# **BOLTON PLANNING & ZONING COMMISSION**

### **a. Continuation: Special Permit Application for 12,000-15,000 SF Pre-Engineered Metal Building Addition for Light Manufacturing, 837 Boston Turnpike, Able Coil and Electronics Co. (#PL-22-4)**

Subject: **Response to Special Permit #PL-22-4 Site Plan Review Comments**

C-1

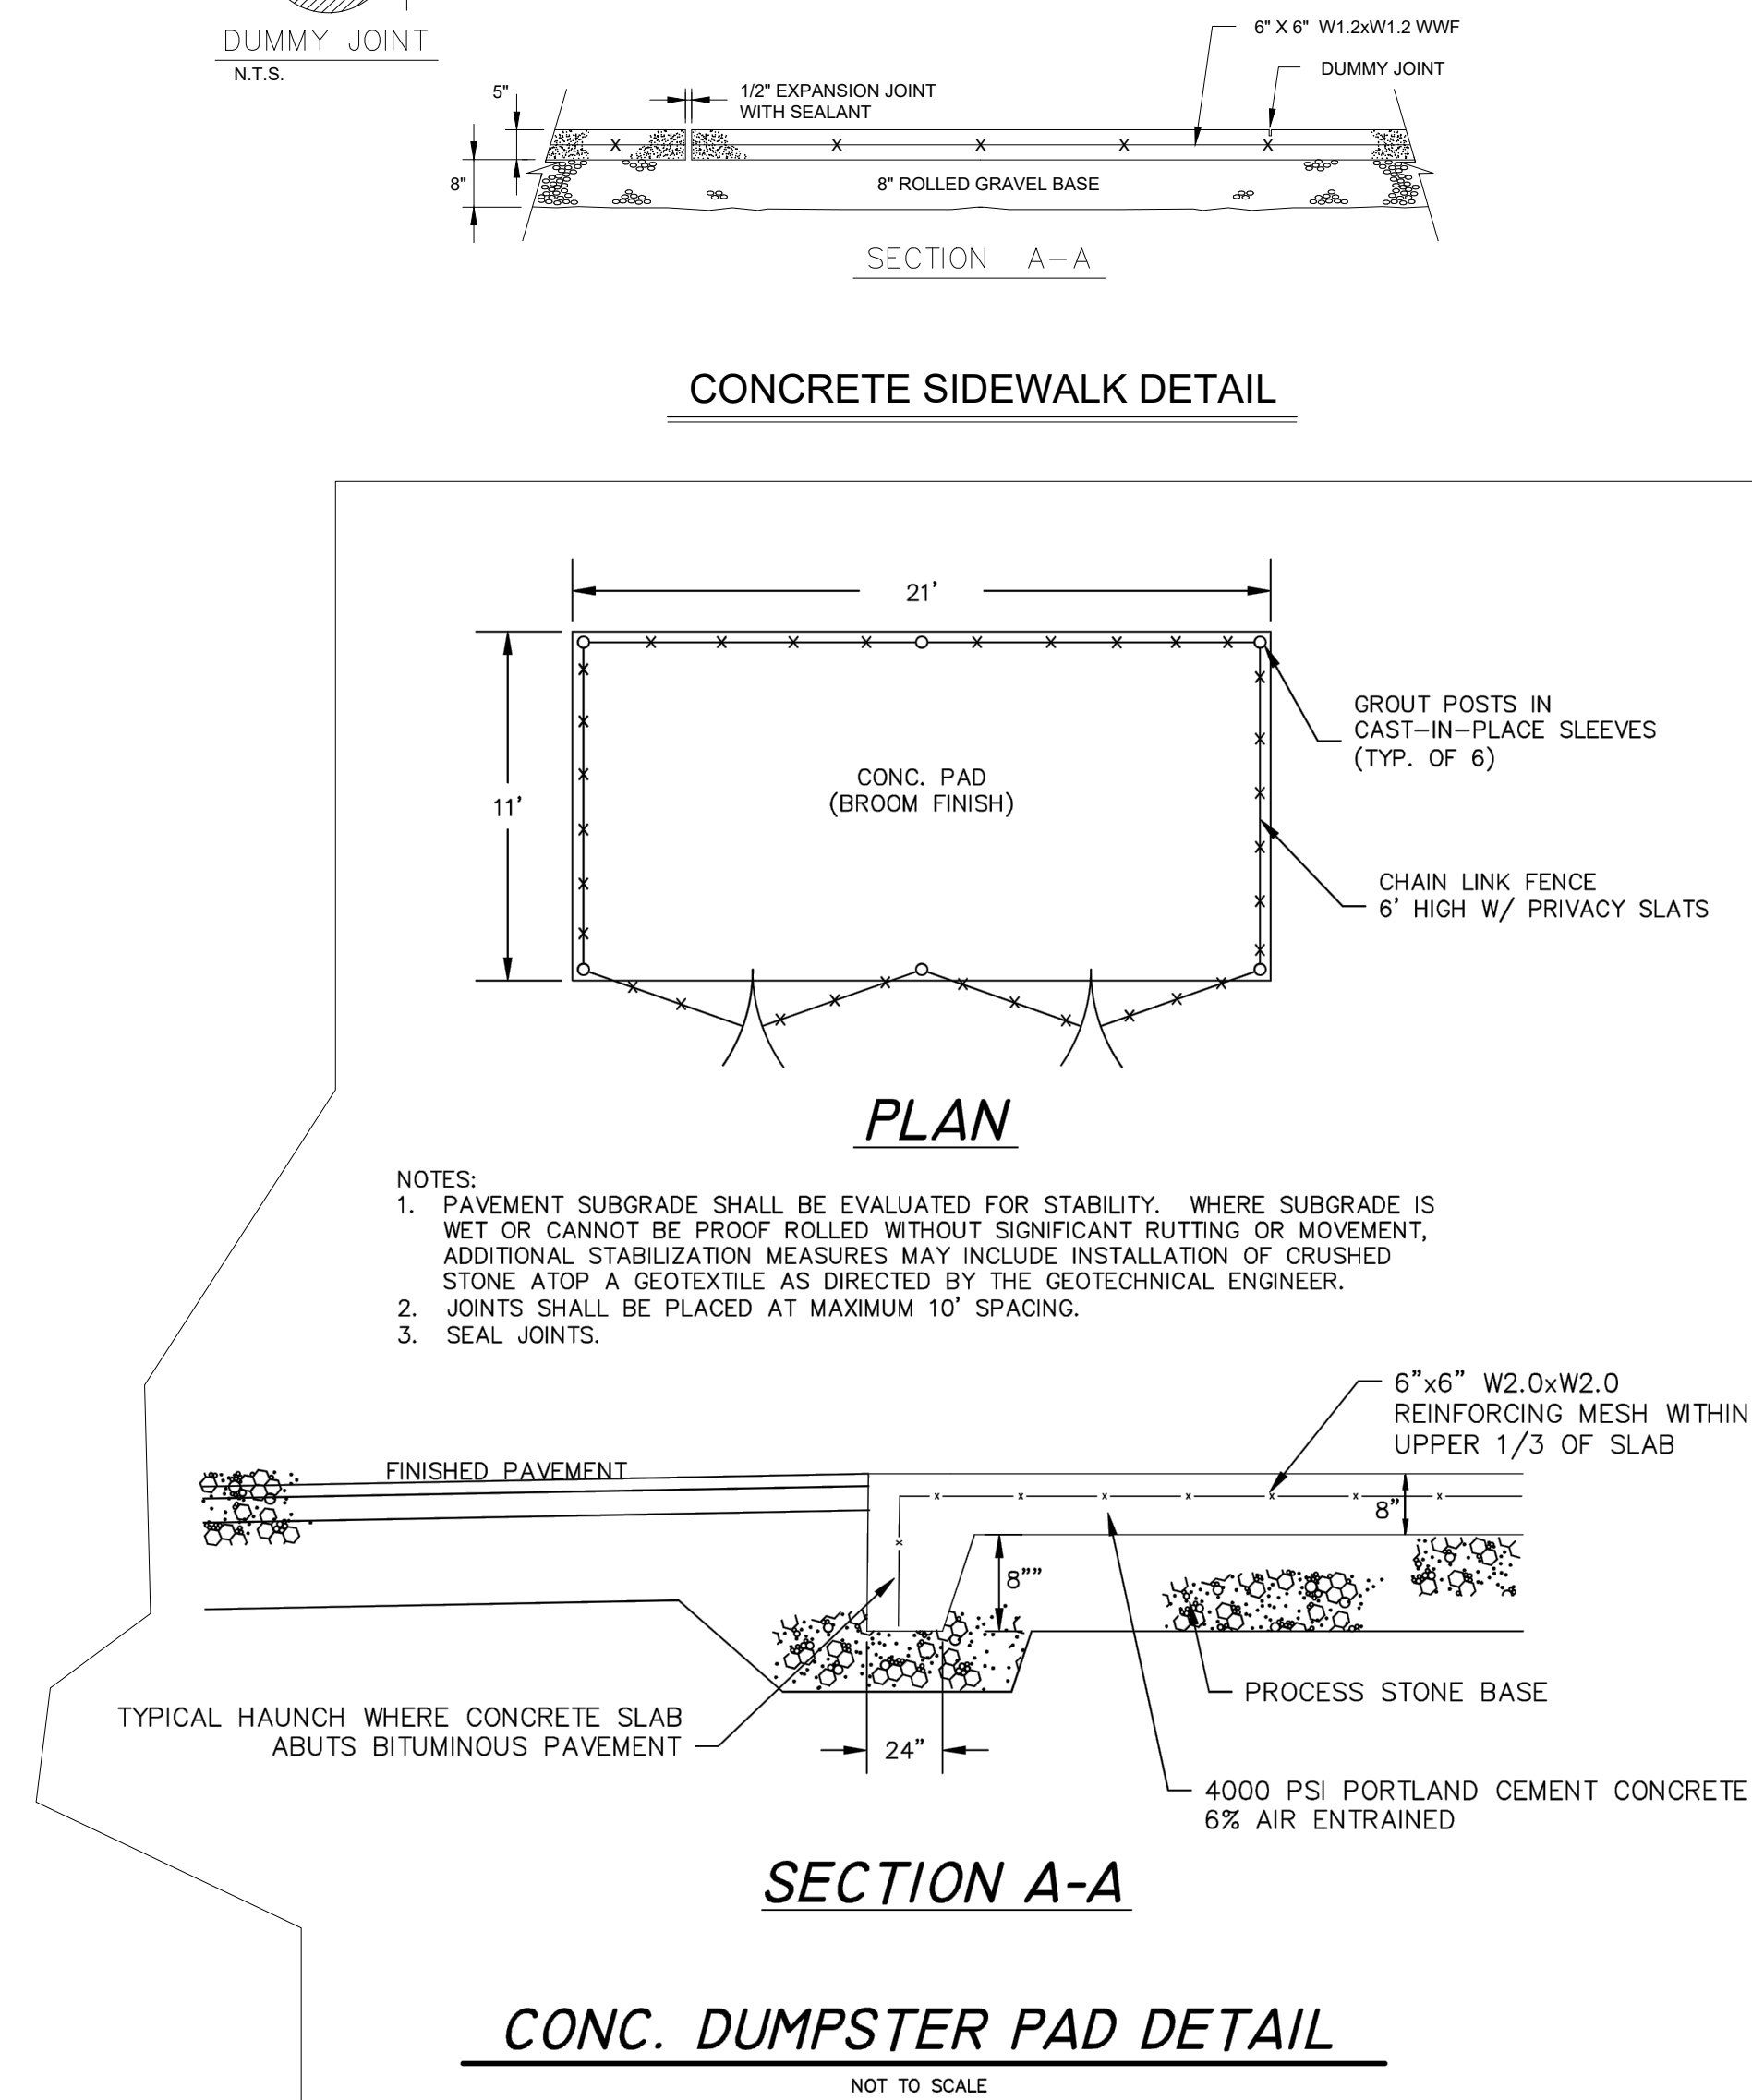
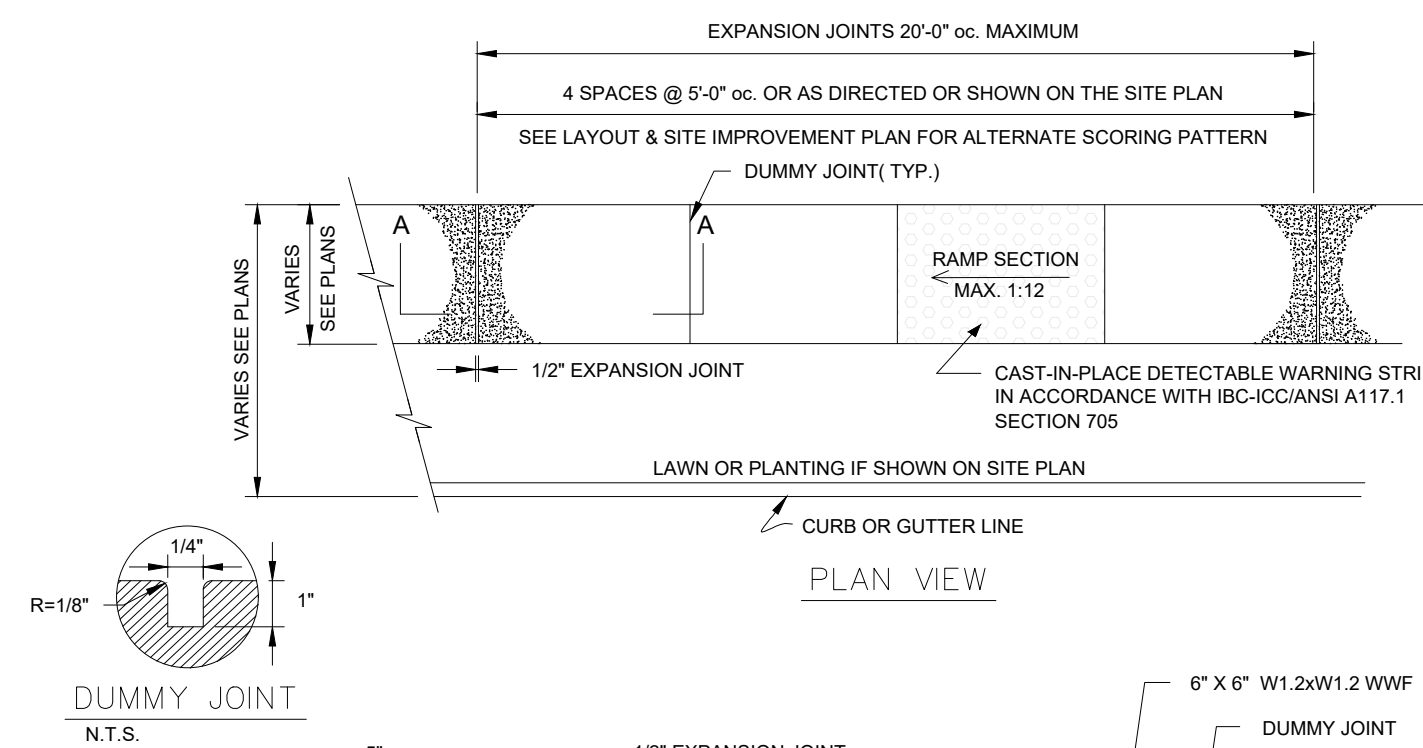
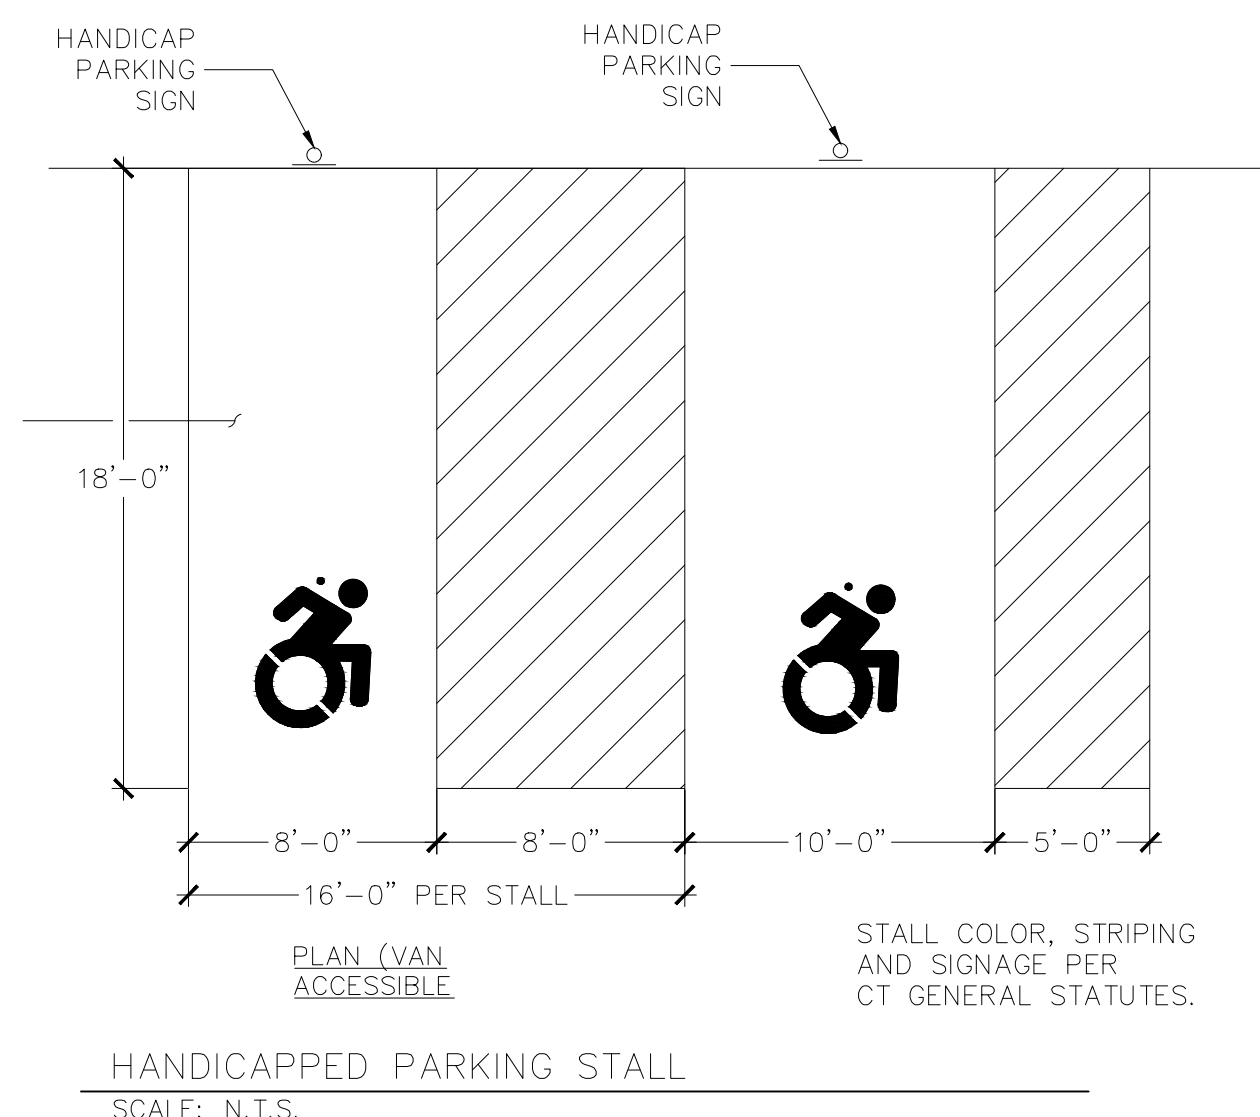
6. **Top of Embankment Width** – The top of the proposed embankment should be a minimum of 8 ft wide.

*Response: The top of the basin is at least 8 feet wide. See revised Site Plan.*

# TRAPEZOIDAL SHEAR KEYS AT DETENTION BASIN

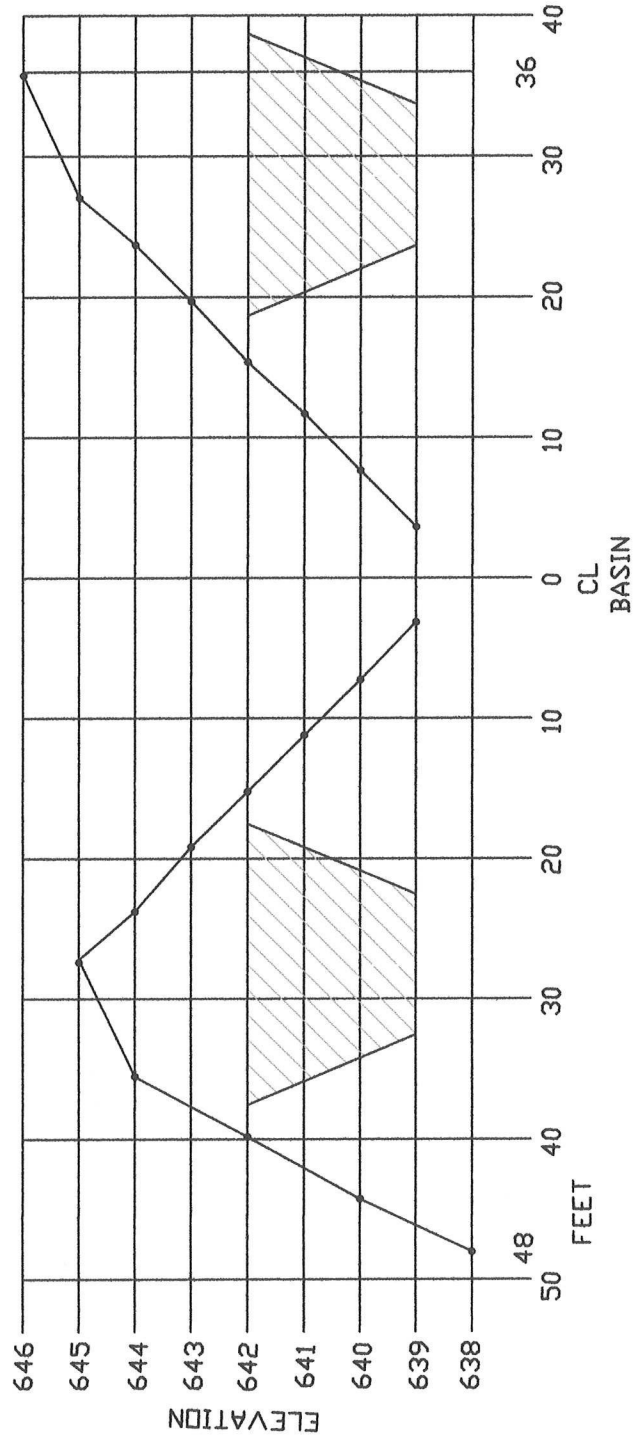
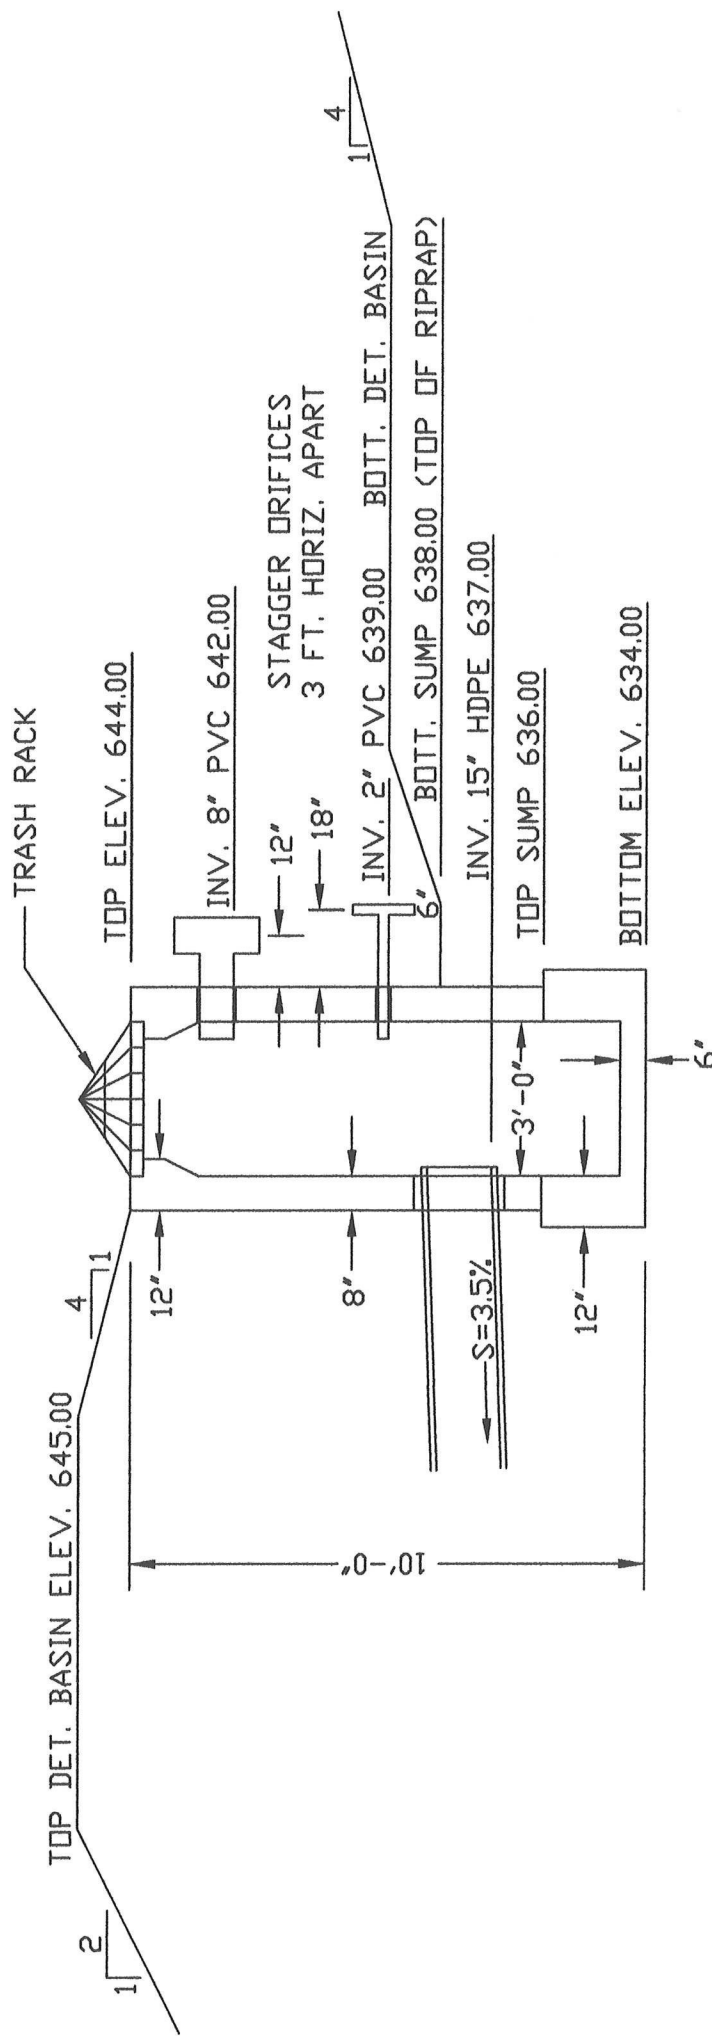
7. **Cross Section of Basin** – A cross-sectional detail should be provided through the detention basin to show where the cuts and fills occur and how the fill embankment will be constructed with regards to existing topography. Additionally, a trapezoidal shear key should be constructed at the interconnection of the fill embankment with the existing subgrade.

Response: A cross section of the detention basin, with a trapezoidal shear key equal to 50% of the berm embankment cross-sectional height and width, is shown below:

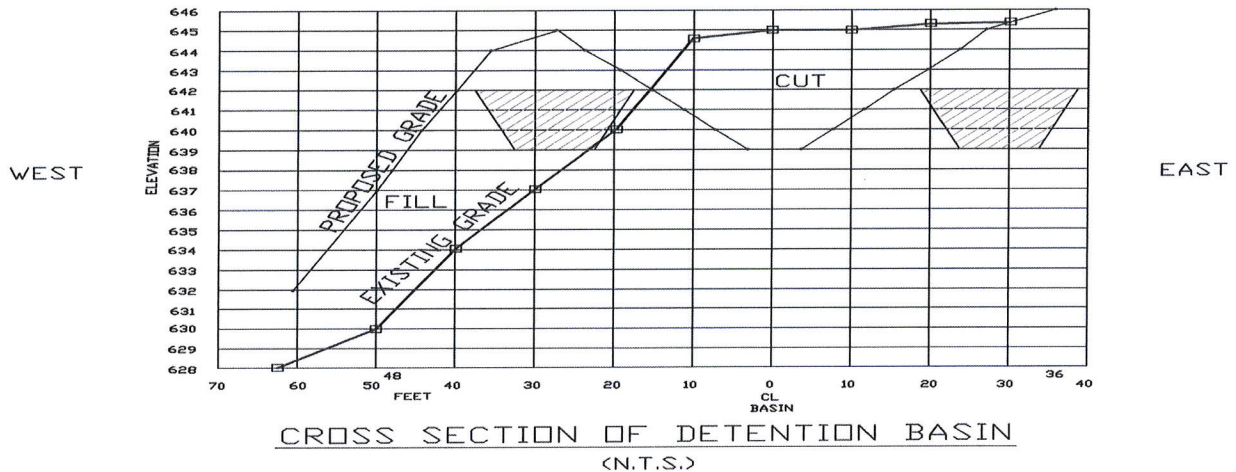
5. **Outlet Structure** – We would recommend that an outlet structure be proposed for the stormwater basin. Currently as shown, the stormwater basin will impound 5.75' of water before cresting at the weir. This poses a hazardous condition and the rate at which the level would drop is indeterminate. An outlet structure would allow the basin to drain to at least the level of the water quality volume and the discharge pipe could be extended to the south to a location with a suitable slope.

*Response: An outlet structure was added to the design. It is a double CL Type II catch basin with two (2) PVC pipe inlets and one (1) 15" HDPE pipe outlet with rip-rap. The Hydraflow Hydrographs program was utilized to size the basin and determine the orifice sizes and elevations. See revised Stormwater Management Report dated 9/06/22.*
